**PITANJA I ODGOVORI**  
**QUESTIONS AND ANSWERS**

**KONKURS ZA IDEJNO RJEŠENJE MJESNOG CENTRA**  
**ZABJELO U PODGORICI**  
**COMPETITION FOR THE CONCEPTUAL DESIGN OF THE**  
**ZABJELO COMMUNITY CENTRE IN PODGORICA**

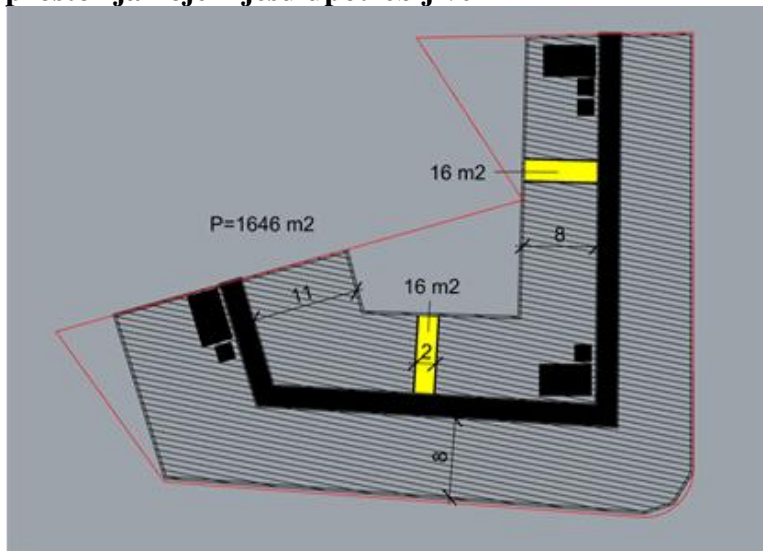
**- U jednom optimalnom sistemu komunikacija nije moguće ostvariti cjelokupan  
program Doma zdravlja.**

**- Ne samo da se program ne može smjestiti u 2,5 etaže, kako program sugerše, već  
se ne može smjestiti ni u pune tri etaže.**

**- Smještanje sadržaja u prizemlje, kako program nalaže, nije moguće.**

**- Površina pod spoljašnjim i unutrašnjim zidovima iznosi oko 110 m<sup>2</sup> i ta  
vrijednost se ne mijenja.**

- In one optimal communication system, it is not possible to realize the entire program of the Health Center. - Not only can the program not be accommodated in 2.5 floors, as the program suggests, but it cannot be accommodated in the full three floors. - Placing the contents on the ground floor, as the program dictates, is not possible. - The area under the outer and inner walls is about 110 m<sup>2</sup> and that value does not change. - In the optimal configuration of communications, which achieves optimal room depths, an area of about 330 m<sup>2</sup> is required for communications: - the simplest occupation of the plot, with the shortest communications, their area is about 250 m. However: - as the sketch suggests, such a configuration results in room proportions that are not usable. Our suggestion is to reduce the capacity of the Health Center by 8%. The part of the laboratory that communicates directly with users can be located on the ground floor, while the rest, which can function independently, with the necessary technological connectivity, can be located on the first floor. With all of the above in mind, our official questions are: 1. Is a proportional reduction in the capacity of the Health Center by about 8% allowed? 2. Is it allowed to divide laboratory diagnostics on the ground floor

Zadata površina doma zdravlja definisana je na osnovu prethodne analize i zahtjeva korisnika i kao takva predstavlja programski okvir koji je potrebno ispoštovati. Učesnici mogu kroz projektantsko rješenje racionalizovati i optimizovati raspored i odnose površina pojedinačnih sadržaja, pritom vodeći računa o minimalnim korisnim površinama za objekte zdravstva. Međutim, planom zadati urbanistički parametri (maksimalna površina pod objektom i maksimalna bruto građevinske površine) se ne smiju prekoračiti.

The given area of the health center is defined on the basis of previous analysis and user requests, and as such represents a program framework that must be respected. Through the design solution, participants can rationalize and optimize the layout and relationships of the surfaces of individual contents, while taking into account the minimum useful surfaces for healthcare facilities. However, the urban planning parameters set by the plan (maximum area under the building and maximum gross construction area) must not be exceeded. See the answer to question no. 28. The parking lot of the patrol service can be in the underground floors.
